Awel y Môr Offshore Wind Farm

Application Errata List

Deadline 1

Document Reference: 1.4

FIGURE NUMBER:
Figure 1

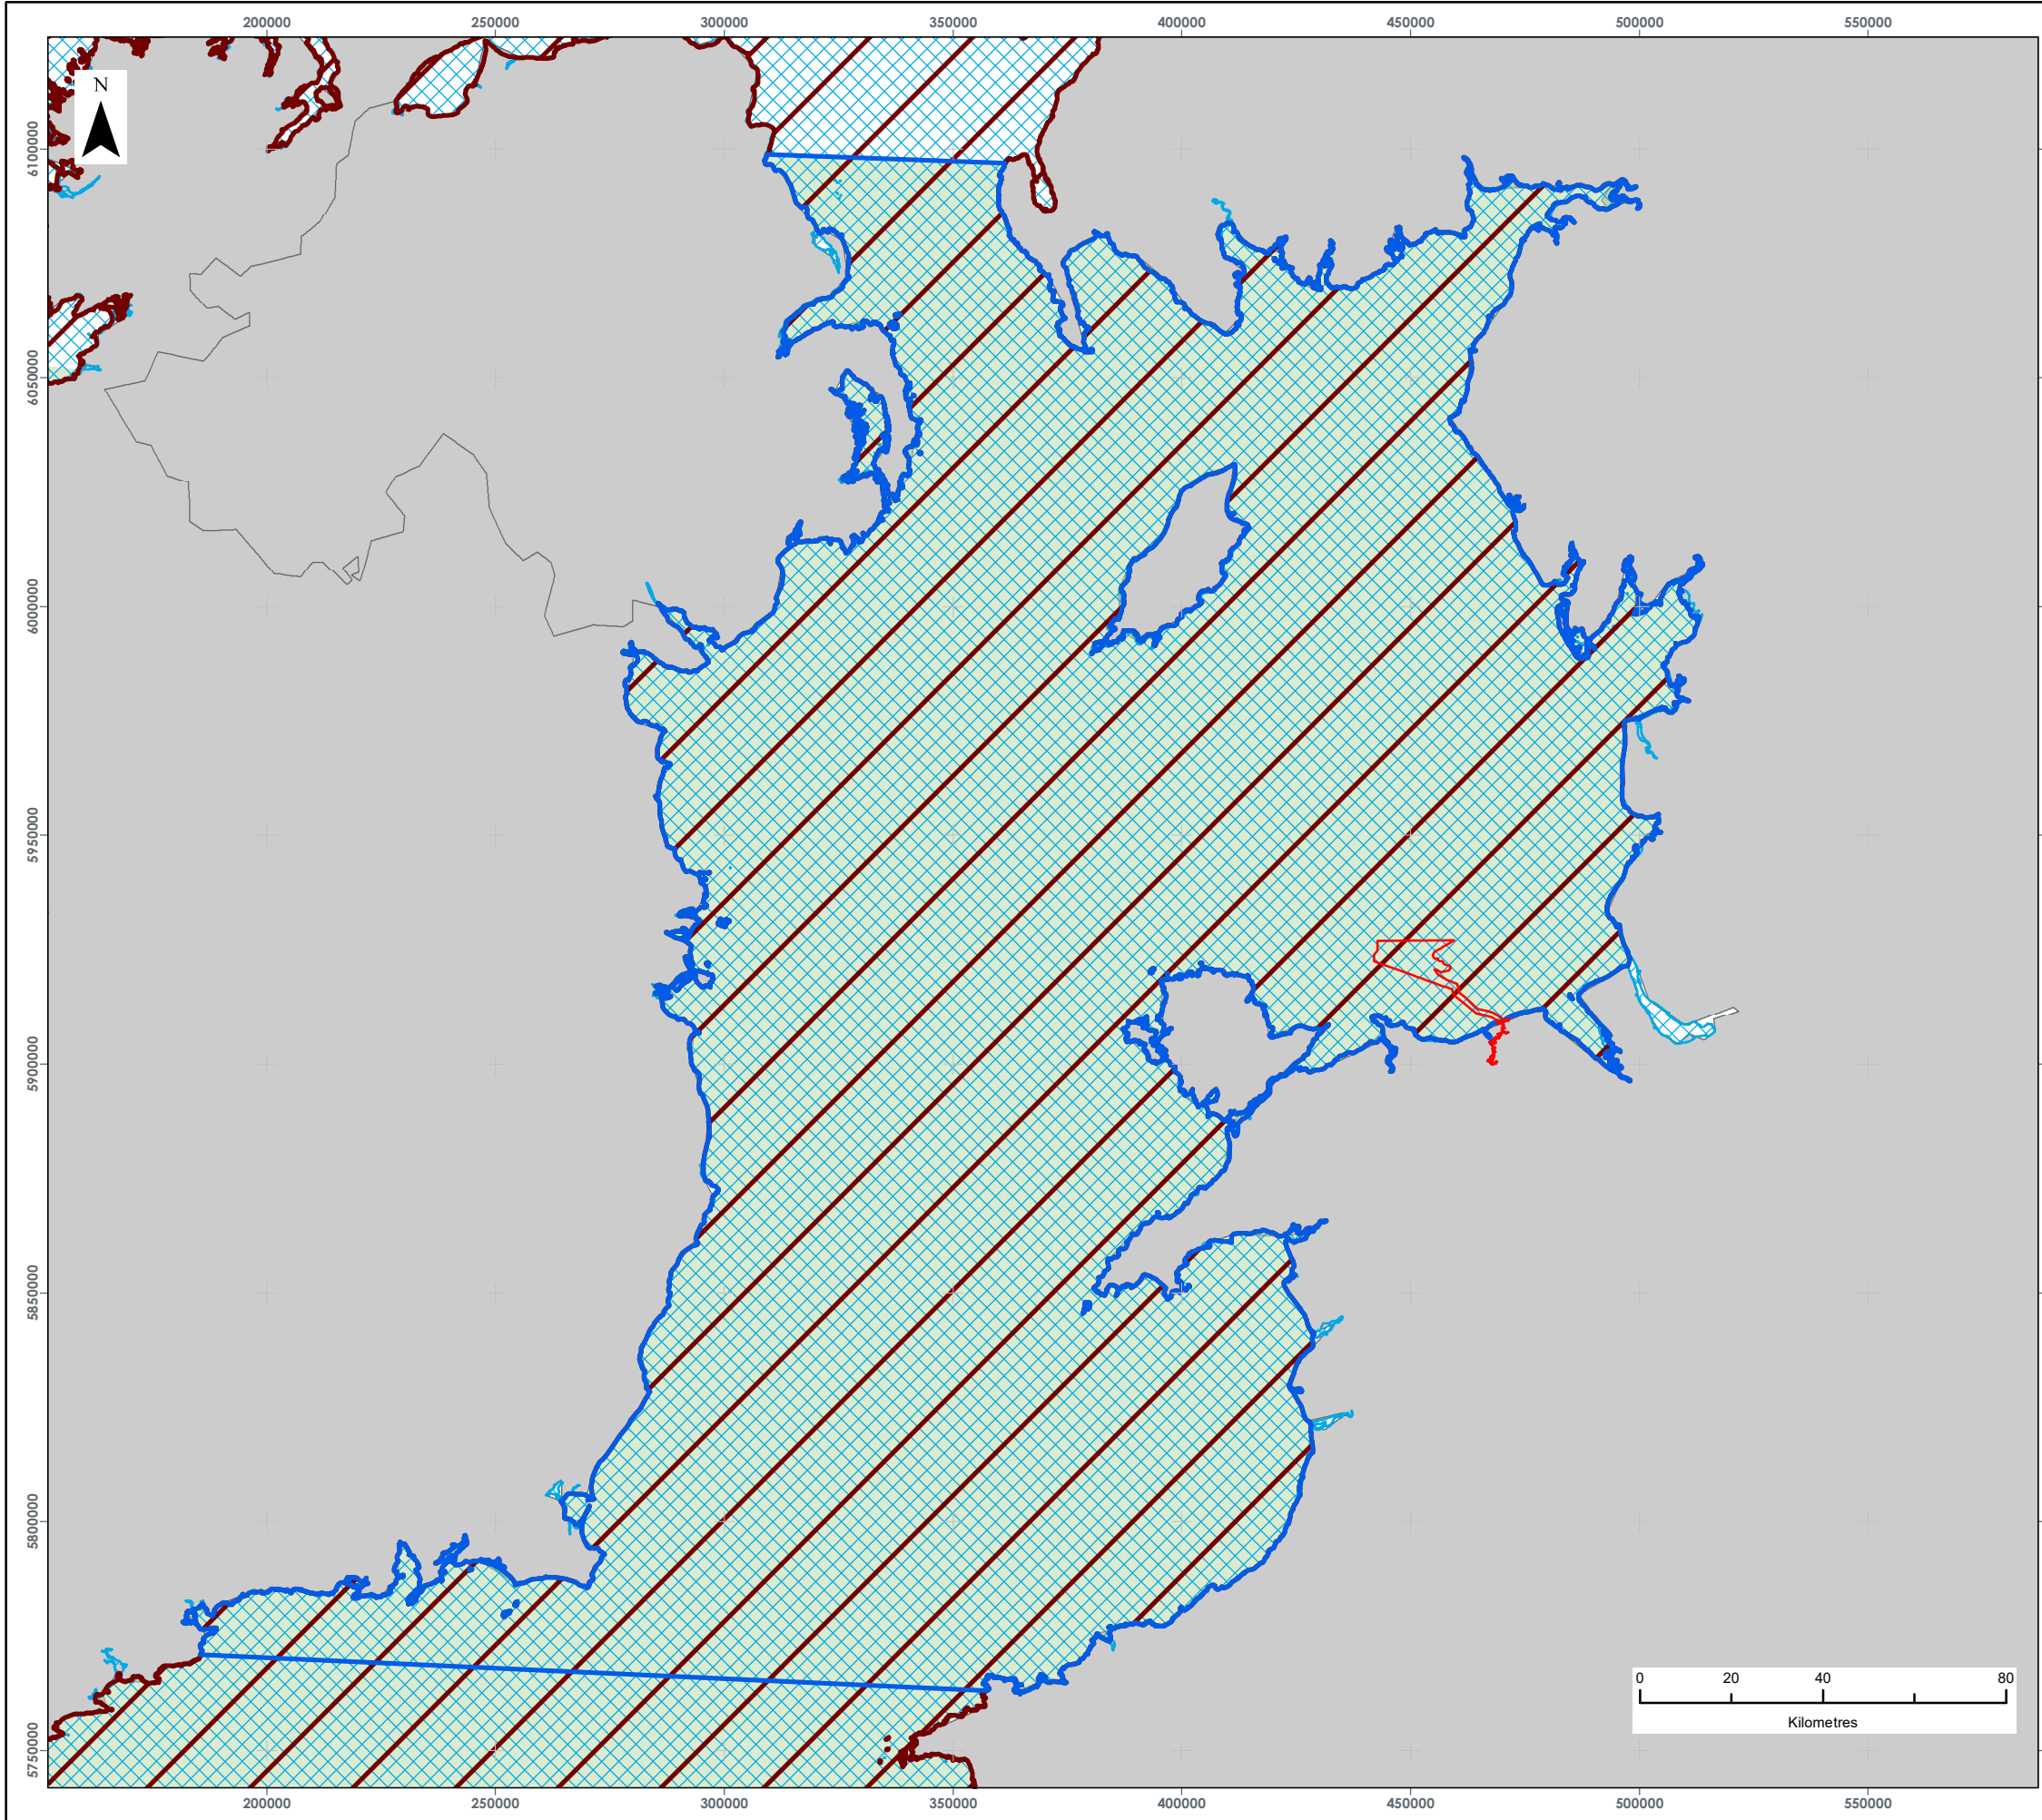
- 7 For completeness, the correct figures are appended to this document in Appendix A, duplicated from the figures presented in APP-053:
 - ✦ Figure 1: Figure incorrectly displayed a black background and omitted base mapping. Corrected figure provided in Appendix A of this document. Note this figure is identical to Figure 1 presented in APP-053.

FIGURE NUMBER:
Figure 2

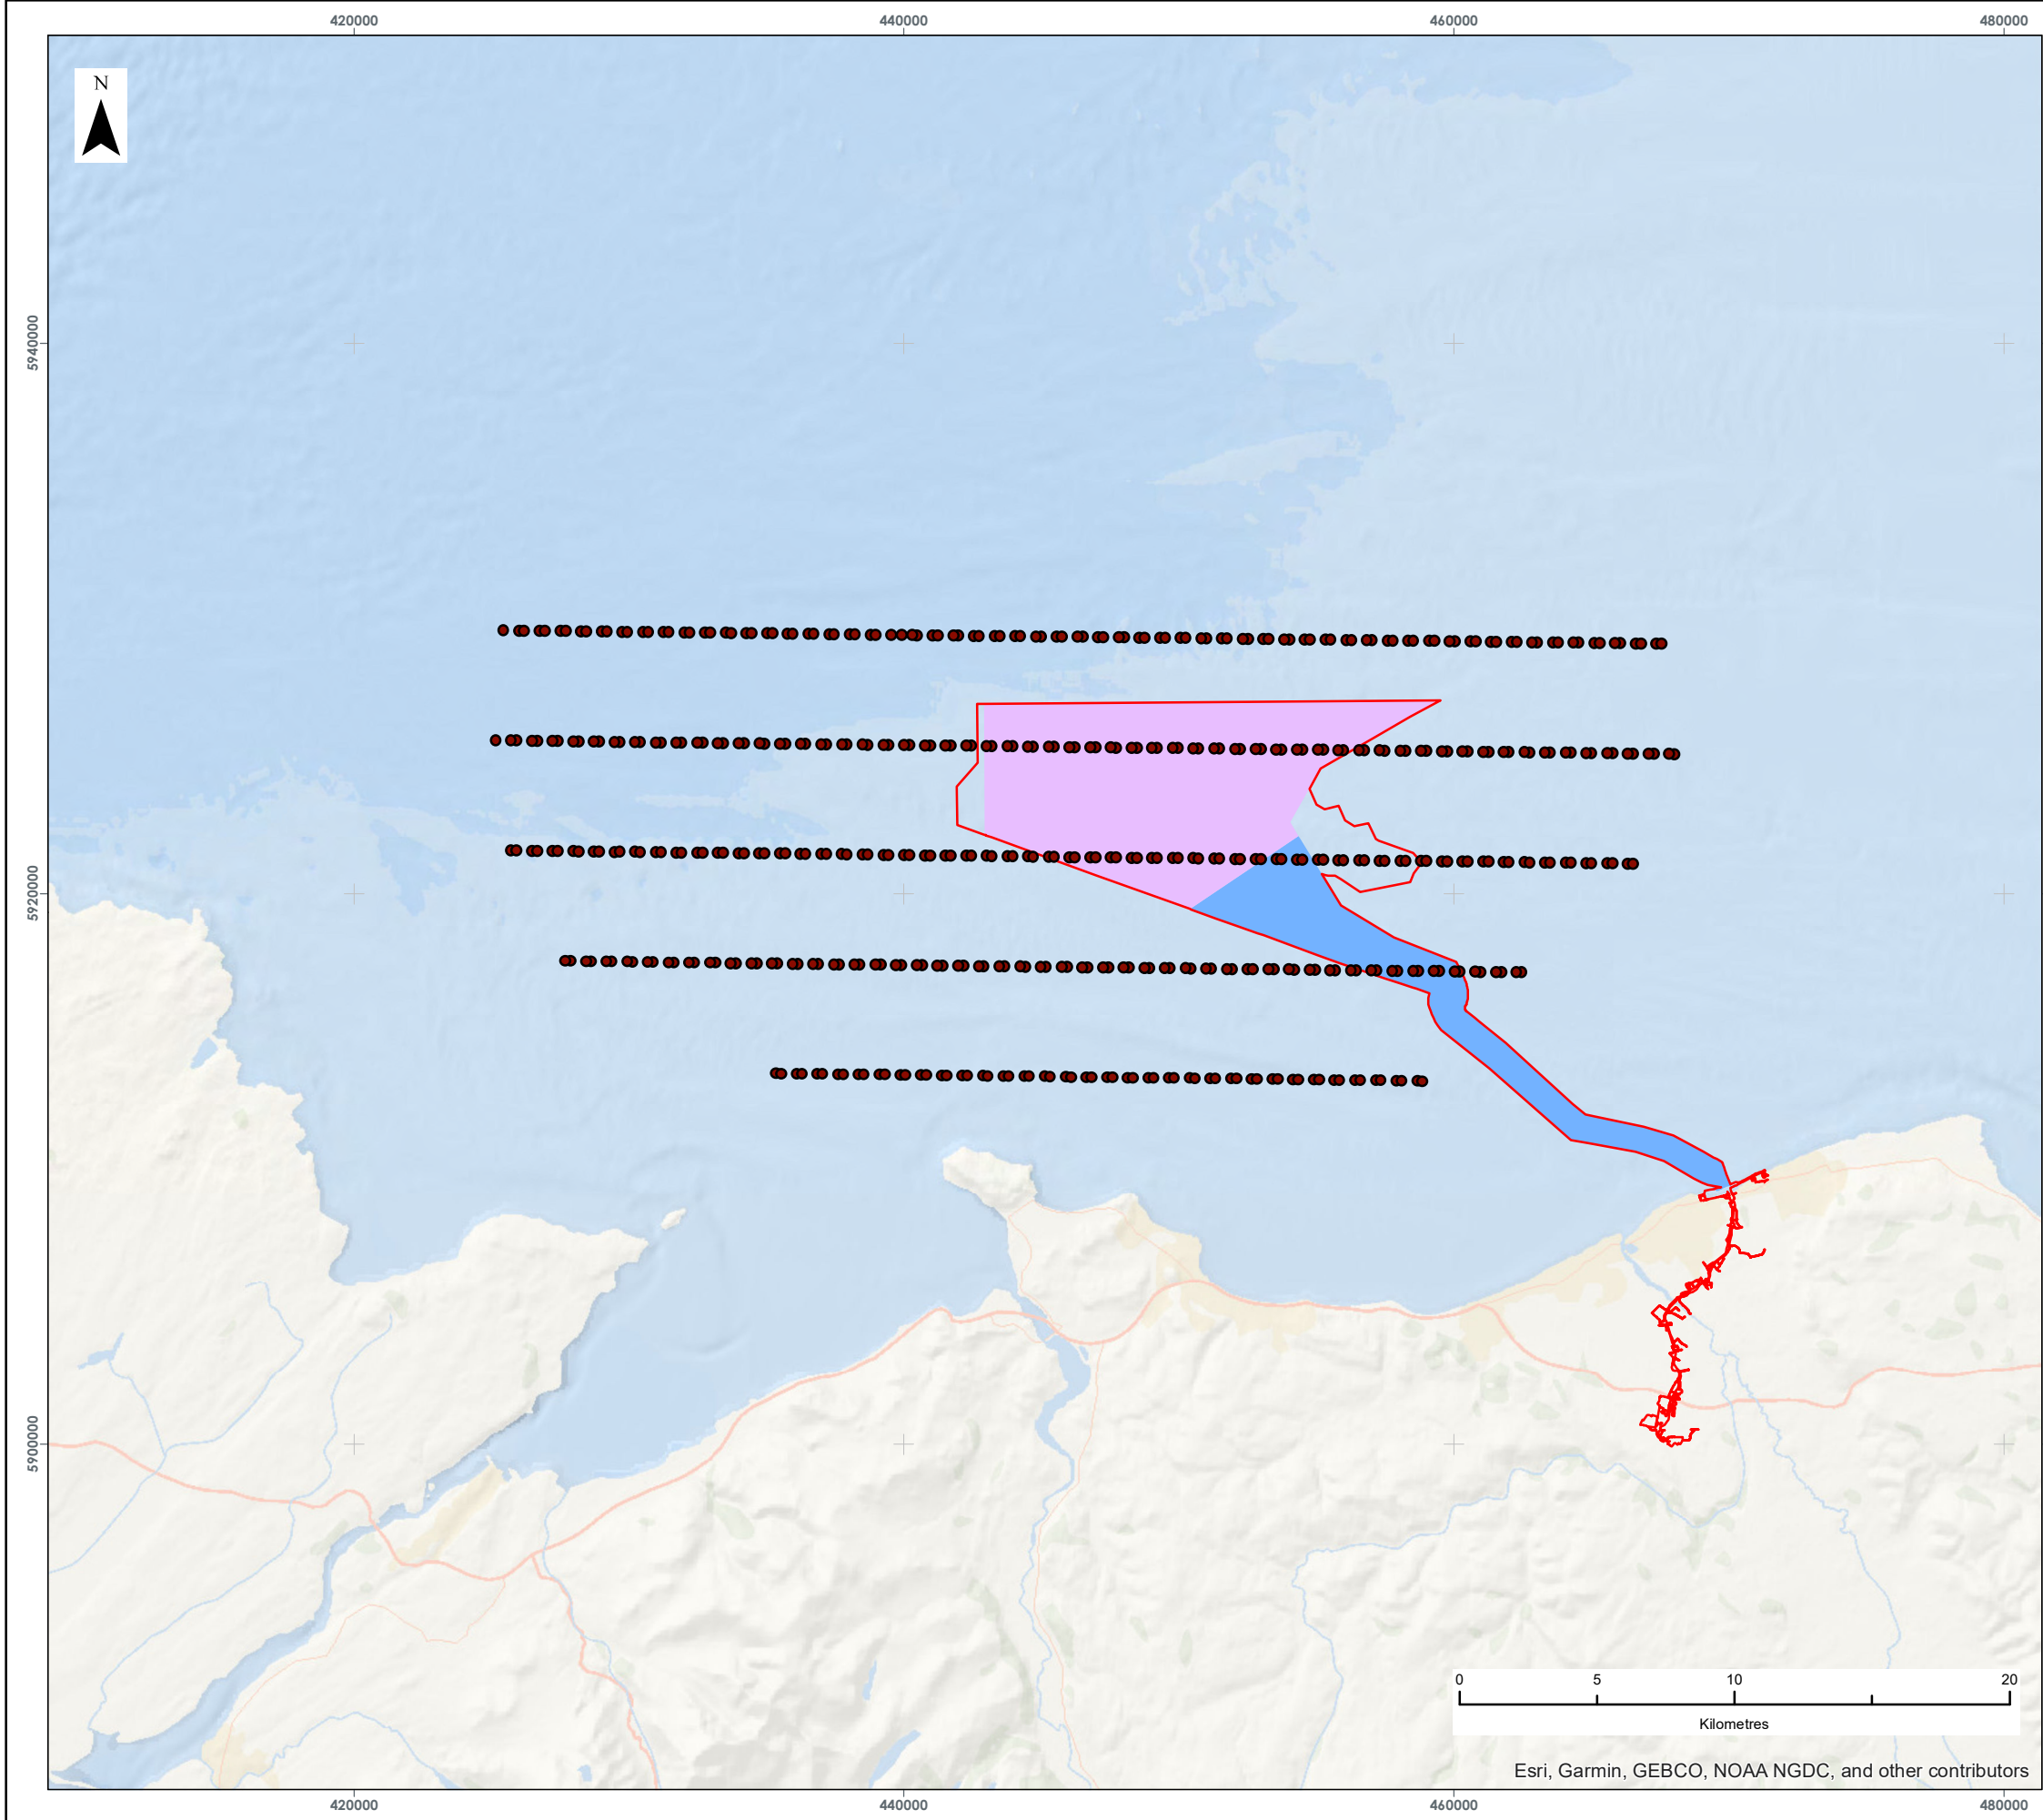
- ▲ Figure 2: Figure incorrectly displayed a black background and omitted base mapping. Corrected figure provided in Appendix A of this document. Note this figure is identical to Figure 2 presented in APP-053.

Figure 18

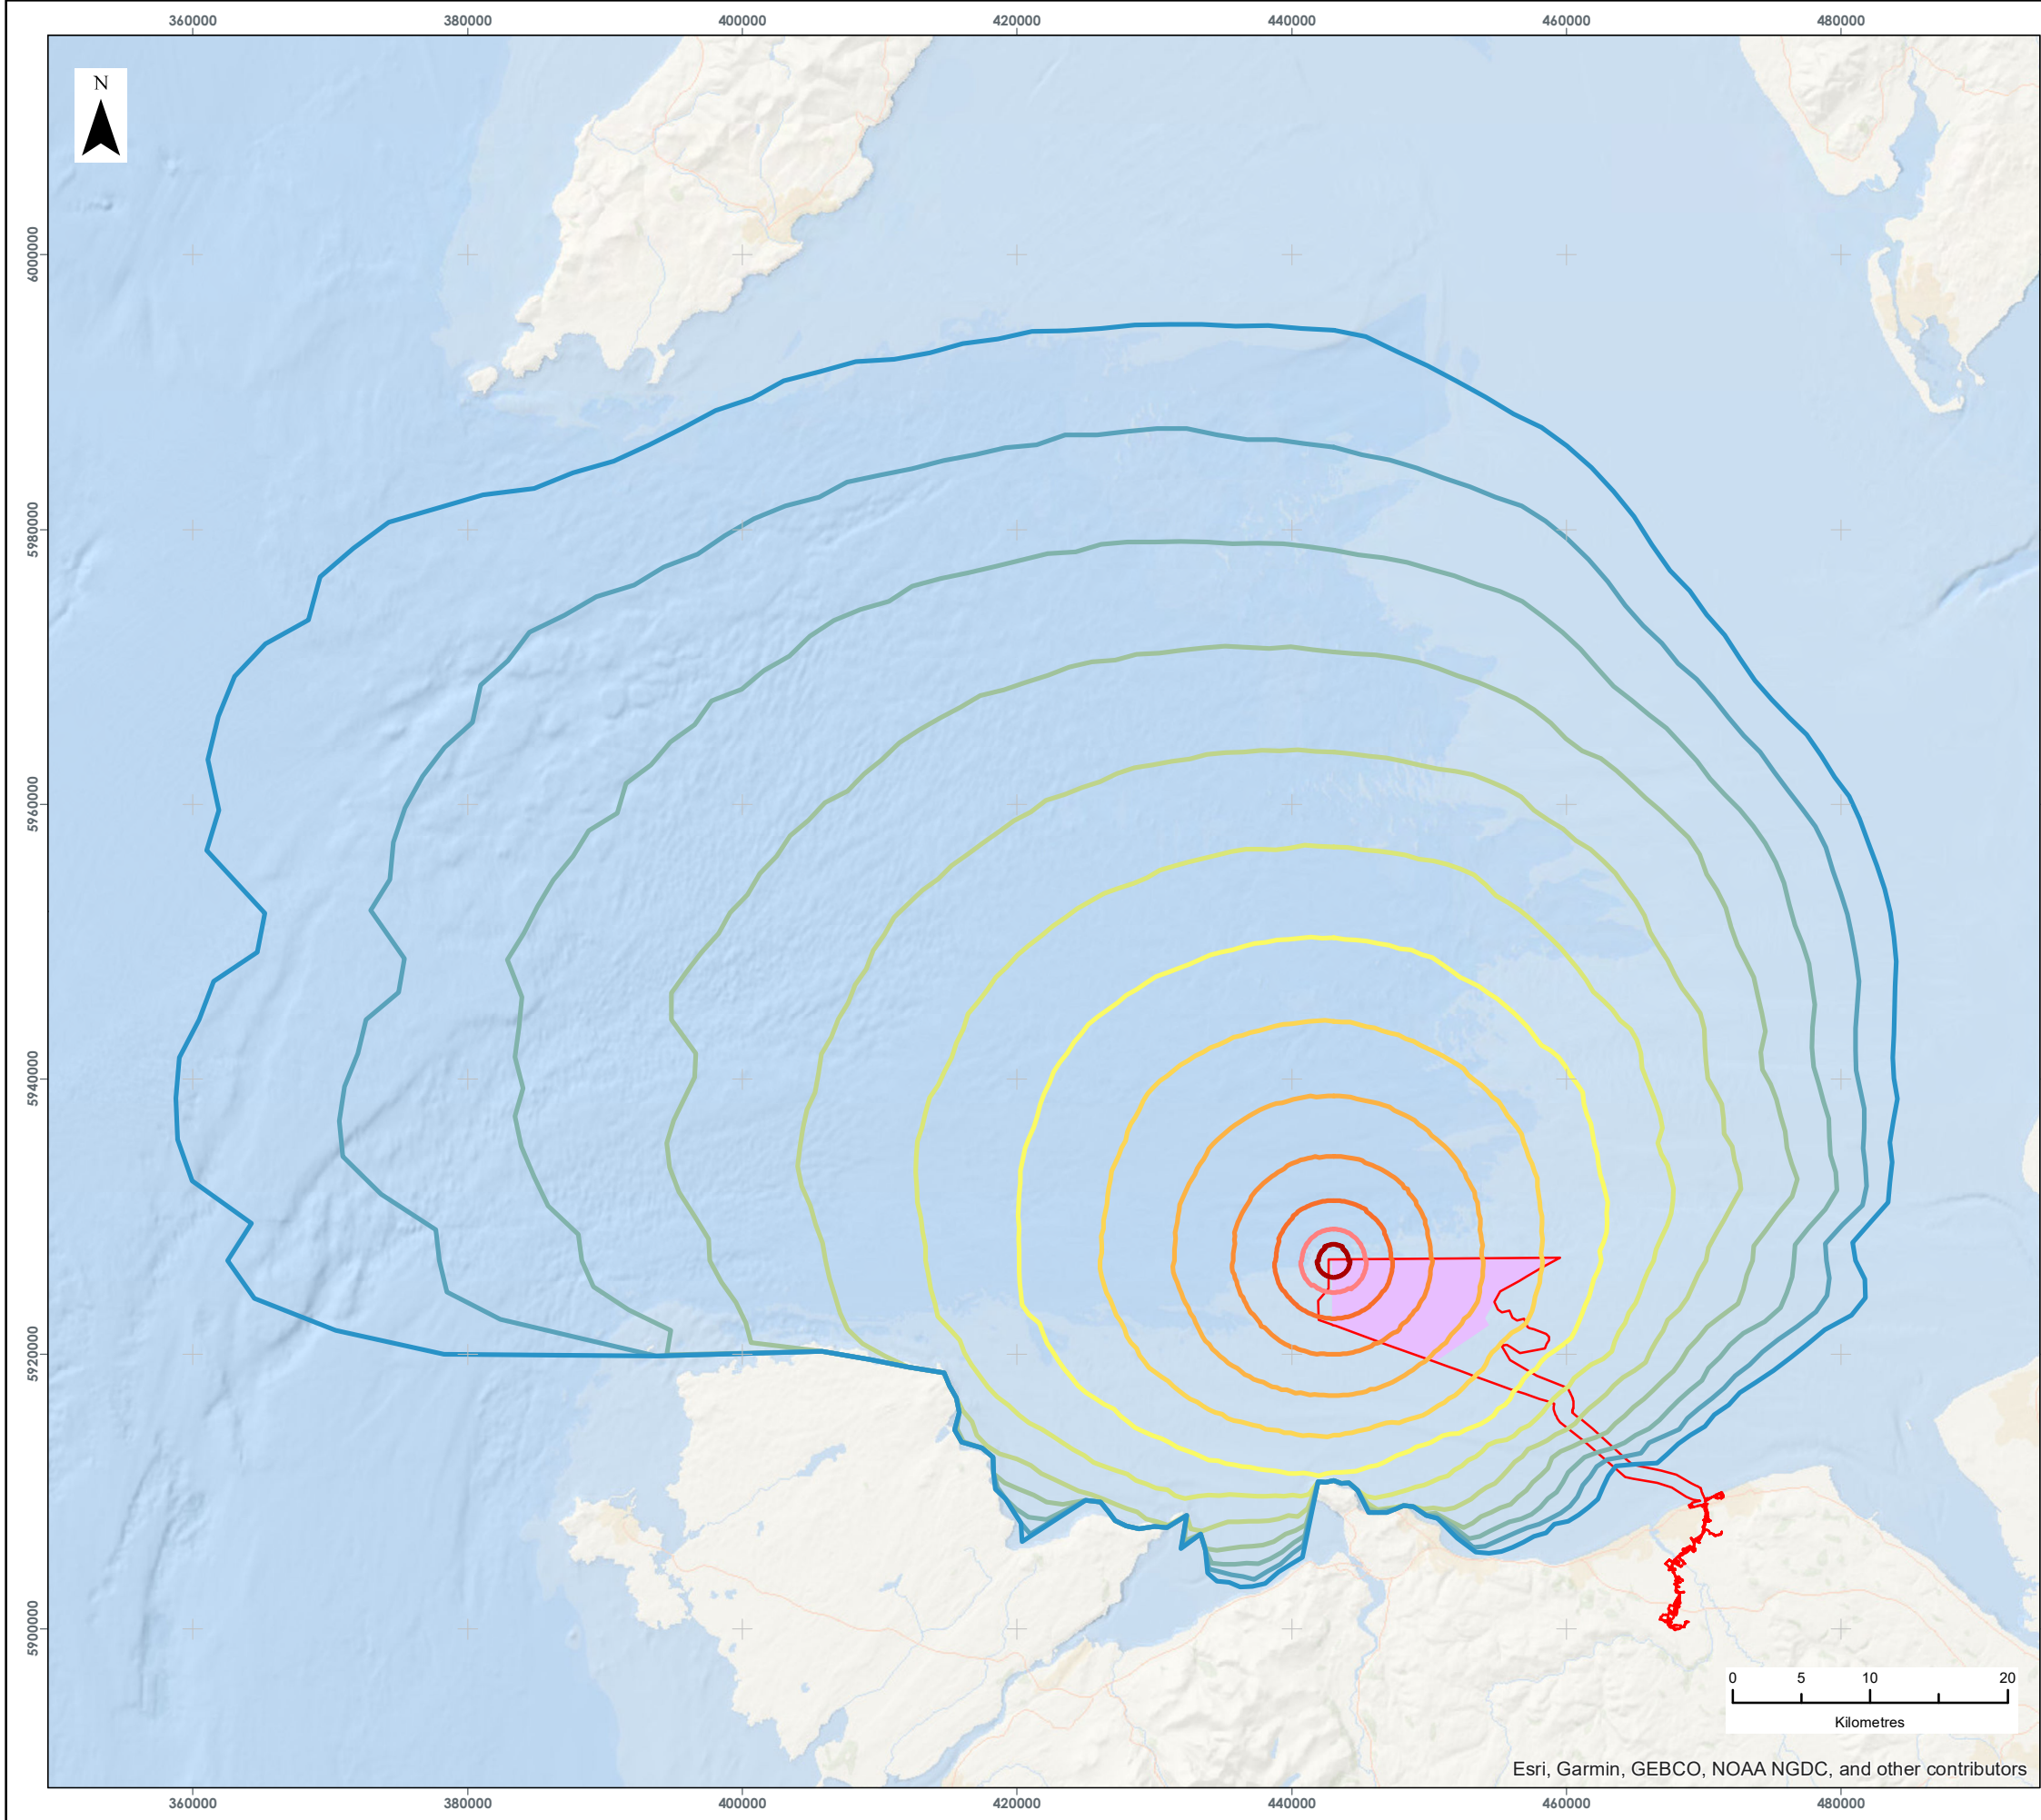
- ▲ Figure 18: Figure incorrectly displayed a partial black background and omitted base mapping. Corrected figure provided in Appendix A of this document. Note this figure is identical to Figure 18 presented in APP-053.
